Traffic Calming (Speed Humps) - Milkwood Avenue

Date: August 29, 2025

To: Etobicoke York Community Council

From: Director, Enforcement and Street Management, Transportation Services

Attachment 2: Speed Humps Locations Plan

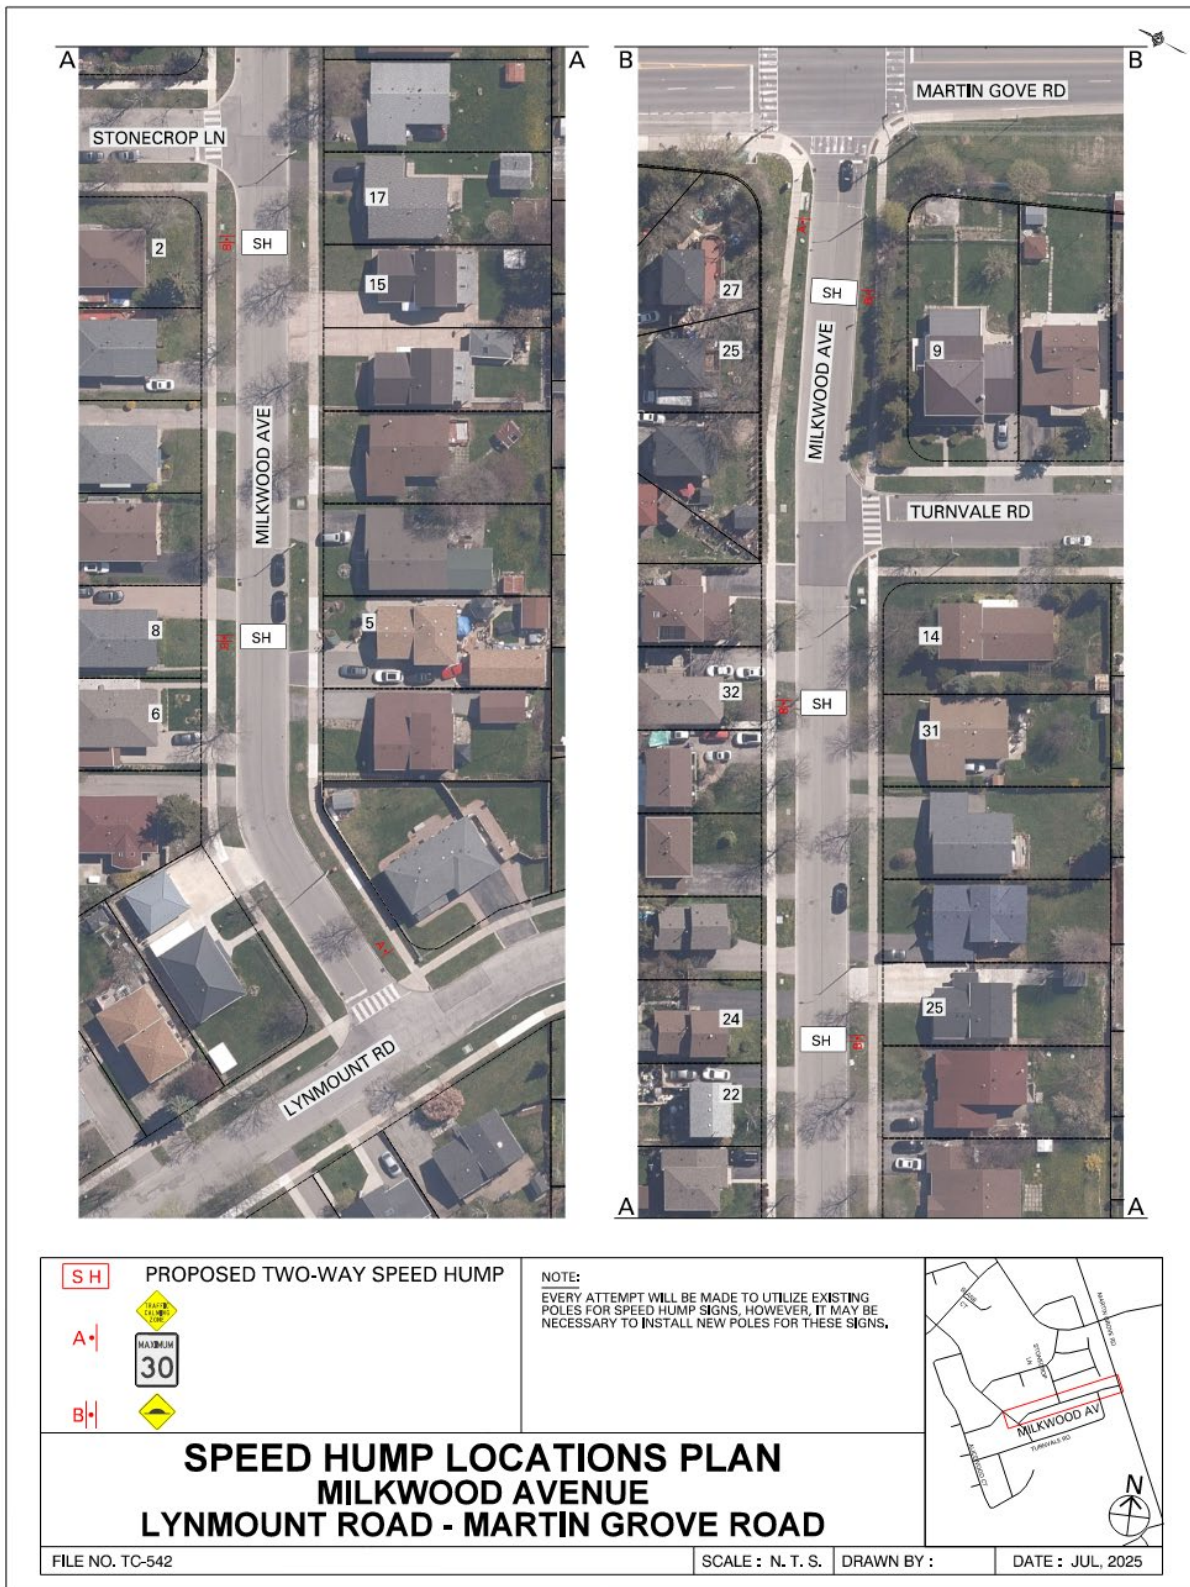
We have received and reviewed the proposal for installation of speed humps on Milkwood Avenue, between Martin Grove Road and Lynmont Road, with the following comments:

The installation of speed humps on Milkwood Avenue, between Martin Grove Road and Lynmont Road, will impact response and transport times for residents that reside on the roadway speed humps are installed. Impacts may extend to community members if Milkwood Avenue, between Martin Grove Road and Lynmont Road, serves access to other roadways. It is important that the applicant understands that the installation of traffic calming devices will reduce the speed that emergency vehicles travel when responding to emergencies on roadways where they are installed.
